# UNITED STATES PATENT AND TRADEMARK OFFICE

APPLICATION NO.	FILING DATE	FIRST NAMED INVENTOR	ATTORNEY DOCKET NO.	CONFIRMATION NO.
10/090,221	03/04/2002	James L. Dunn	P6228	3497

# Office Action Summary

- I. Claims 1-28, drawn to a cart for collecting medical waste, classified in class 604, subclass 319.
- II. Claims 29-32, drawn to a cap, classified in class 220, subclass 235.
- III. Claims 33-40, drawn to a system comprising a cart with a canister and drainage station for cleaning the canister, classified in class 134/56R.

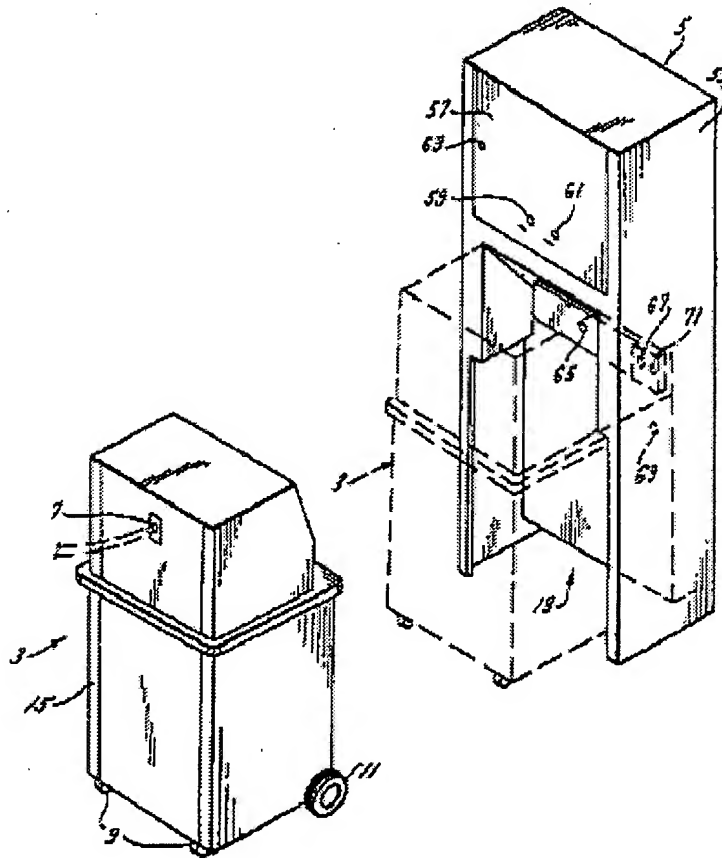
Claims 1, 2 and 9 are rejected under 35 U.S.C. § 102(b) as being anticipated by Parker (US 4,863,446).

Parker teaches a cart (3) for collecting medical waste comprising a body (15) supported by a plurality of wheels (11);

a container (81) supported by said body (15) and having a drain port (53) therein;

a cap positioned on said container (81) and including a patient port (31) and a vacuum port (7) said patient port (31) adapted to selectively communicate with a suction line (33) and said vacuum port (7) adapted to selectively communicate with a vacuum source (fig. 9); and

a liquid level detector (21) in communication with said container (81);

whereby medical waste is collected in said container (81) through a suction line (33) connected to said patient port (31) when said vacuum port (7) is connected to a vacuum source (fig. 9) and the collected medical waste in the container (81) may be detected via the liquid level detector (21)(see fig. 1, below).

Regarding the container cap, the container (81) taught by Parker is designed to operate under a vacuum and inherently has some sort of cap to provide the sealed enclosure necessary to provide such a vacuum.

Regarding claim 2, Parker teaches a vacuum regulator (35).

Regarding claim 9, Parker teaches a filter (75) in communication with said vacuum port (7).
